LANDSCAPE

DESIGN VARIATION FROM DA

Updated Landscape Plan - Level 2 Terrace

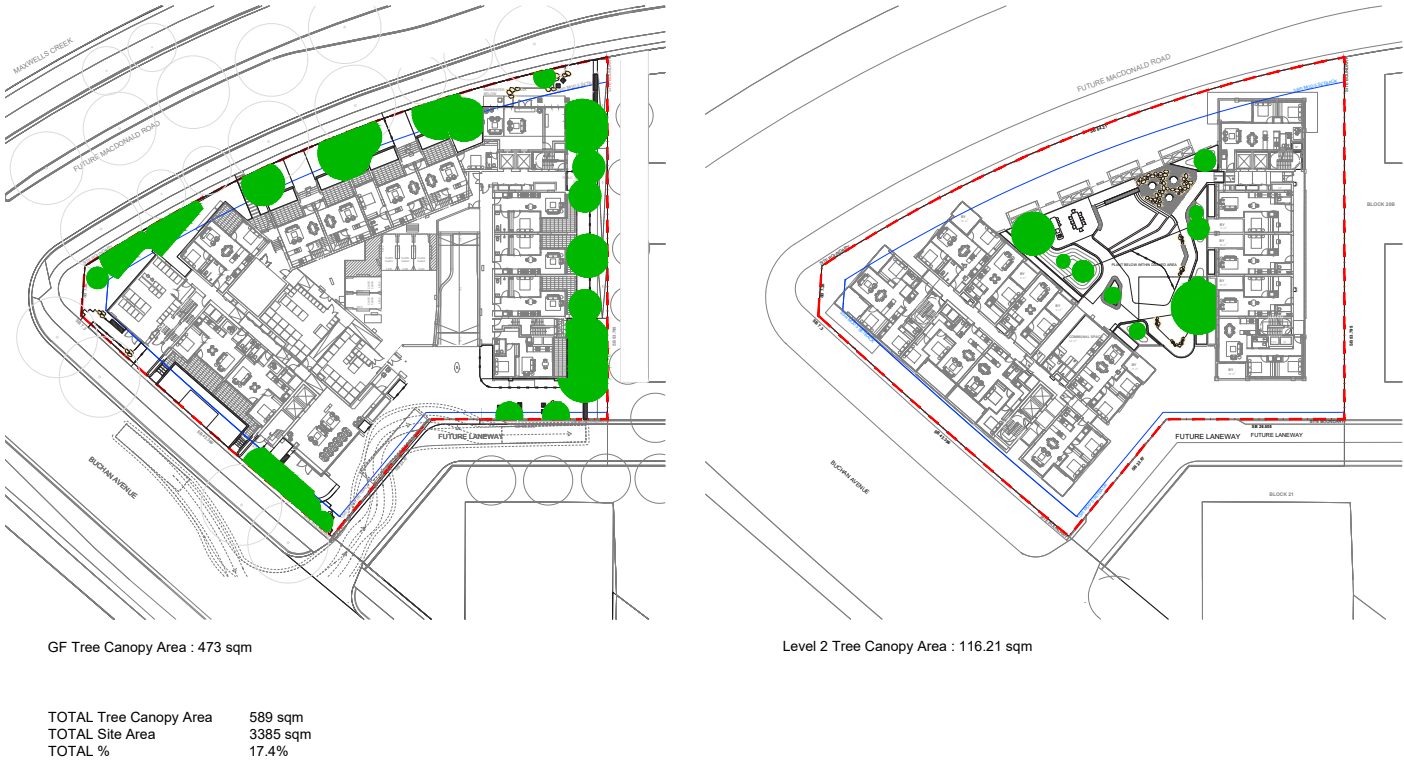
- Minor layout update including retaining wall realignment, seat relocation & associated paving extension.

The layout update contributes to better pedestrian movement desire line and opens up space to the BBQ facility from the pathway. The relocation of seating to the play zone addresses the demand for child supervision. No variation to the proposed plant species and locations.
